37/3-97Y 7318 Carroll Avenue
(Takoma Park Historic District)

SUBJECT: Historic Area Work Permit

HISTORIC PRESERVATION COMMISSION STAFF REPORT

PROPOSAL: Alterations & 3rd floor addition

EXISTING 2nd FL.

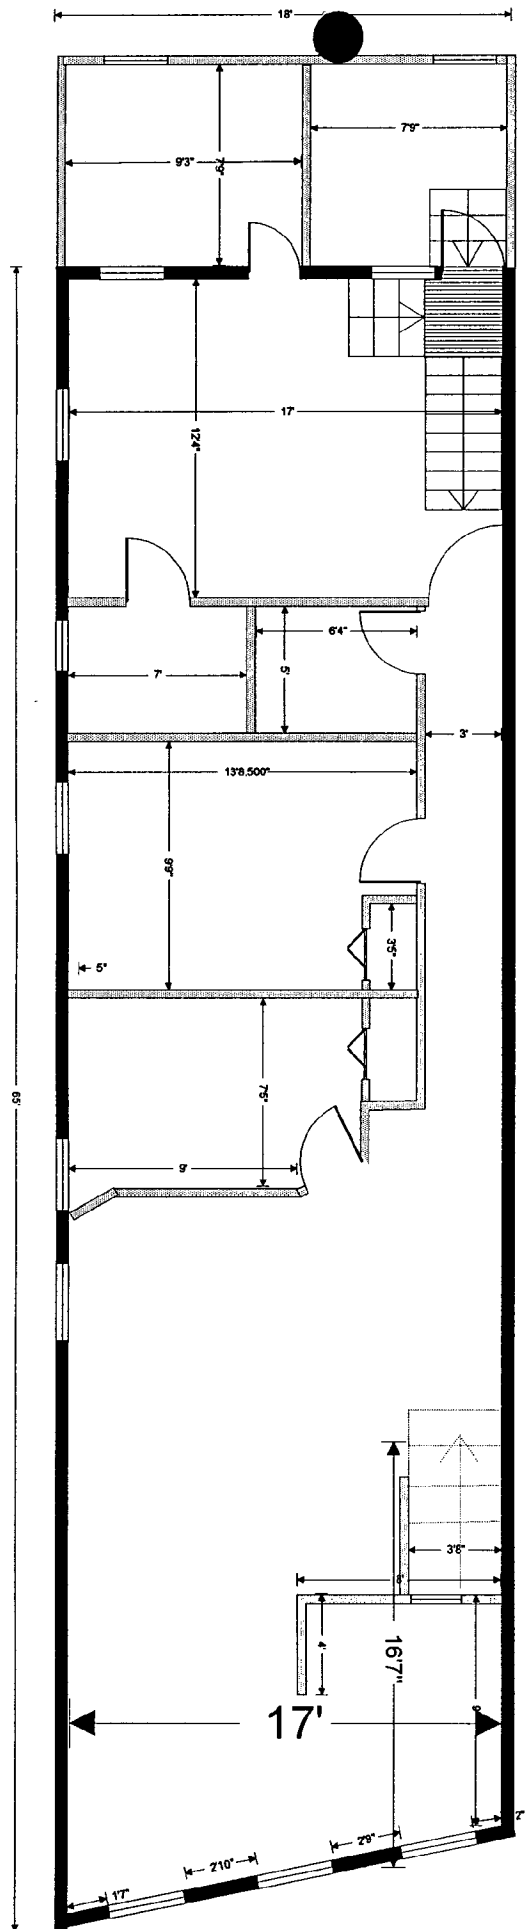
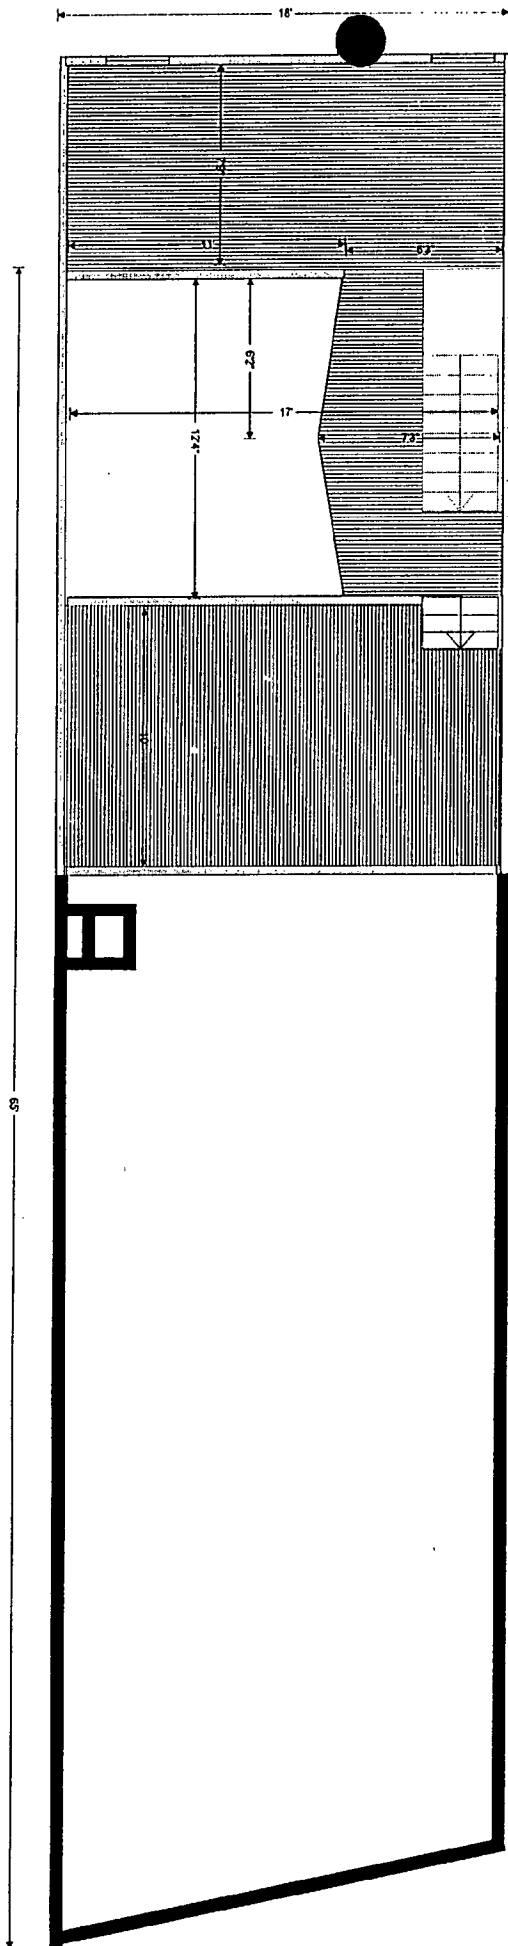
* You have to revise your drawings to reflect the removal of the third floor addition, & bring the revised set in for HAWP stamp prior to going to DPS for your building permit

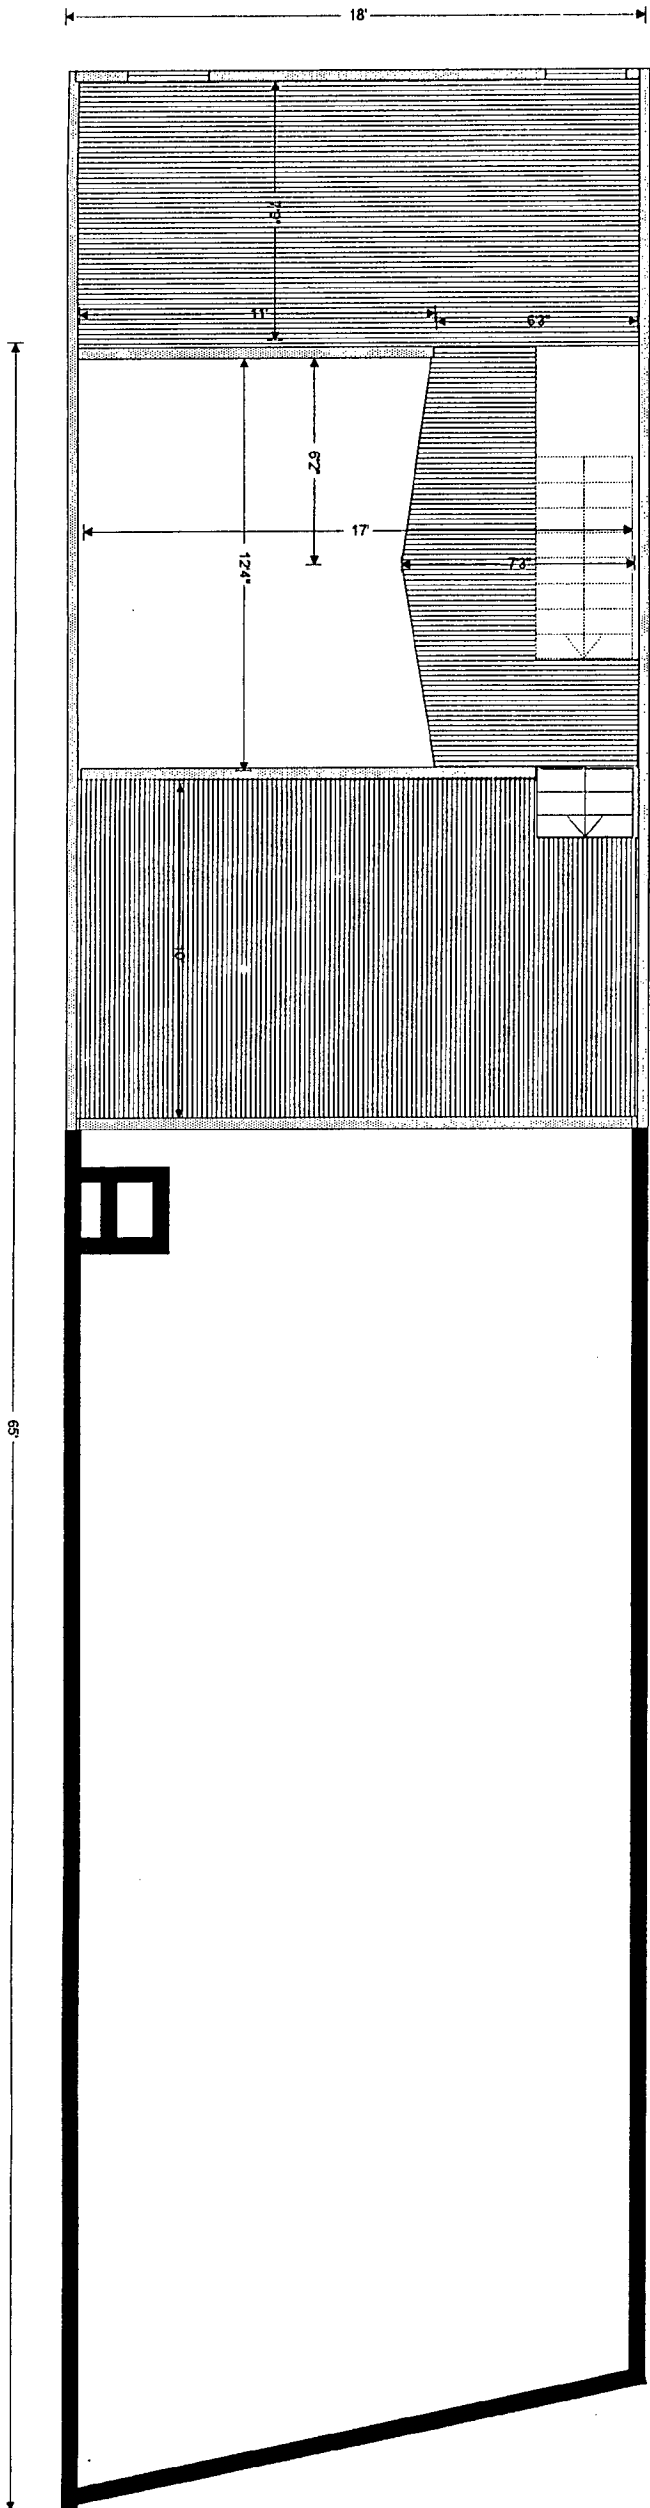
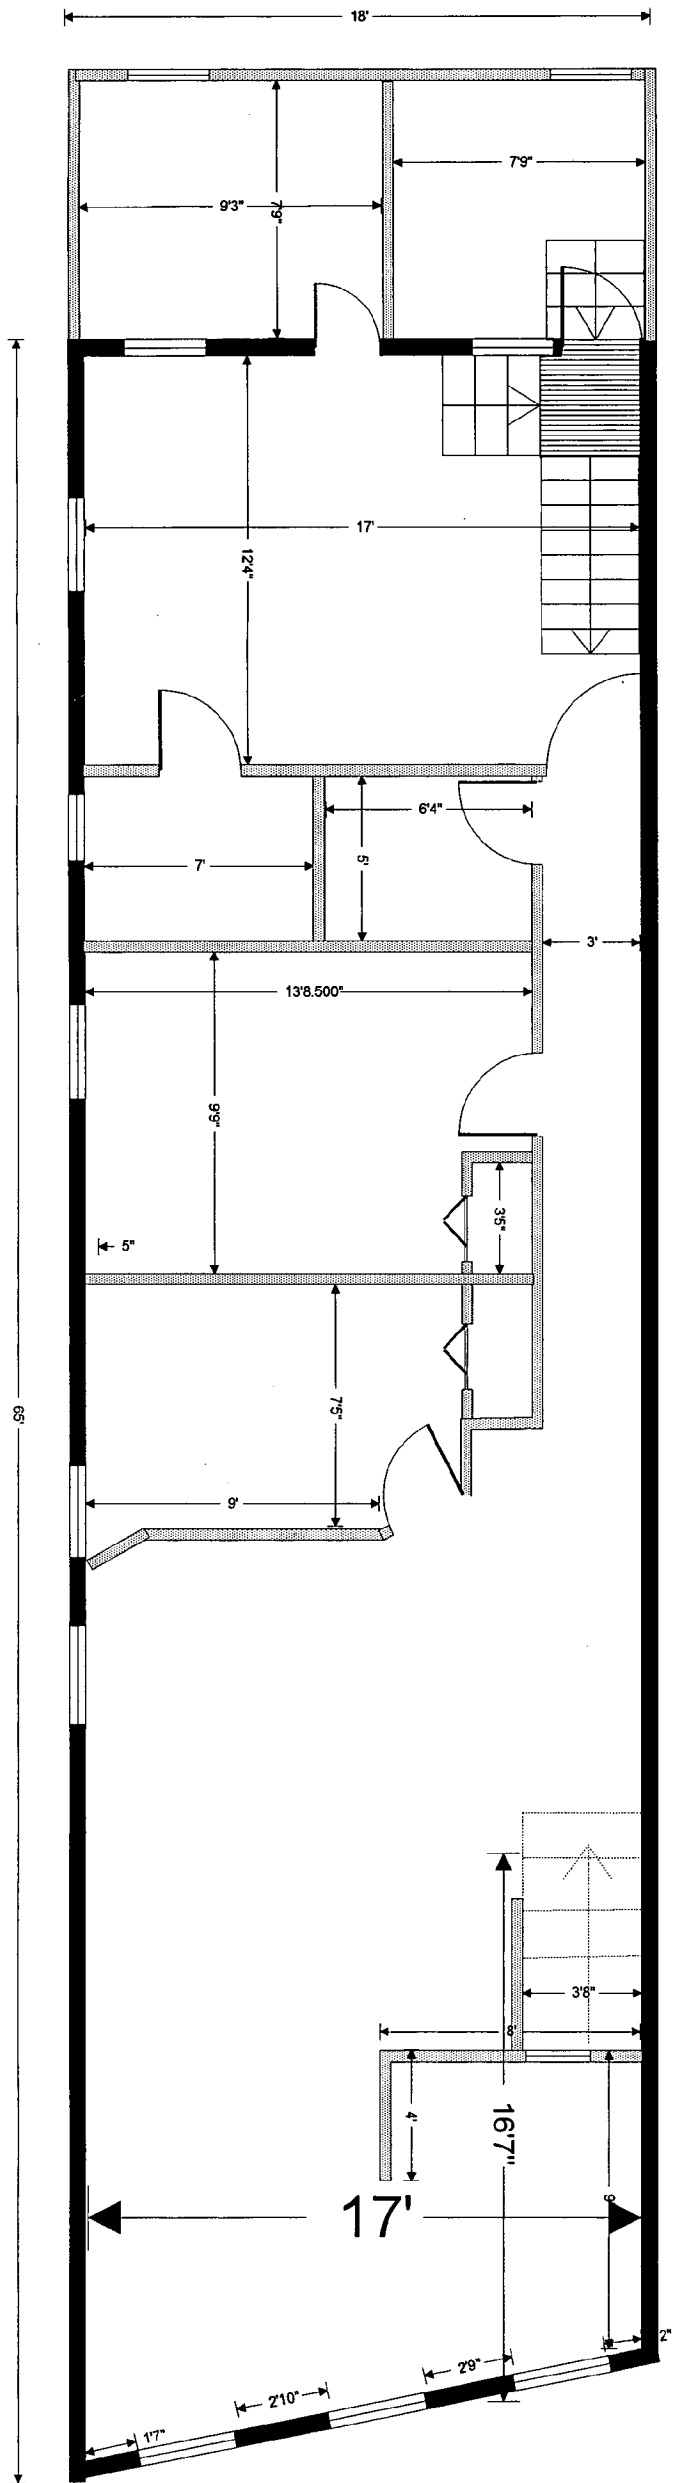
Drawings to be
revised to reflect
removal of 3rd fl.
7.10.97
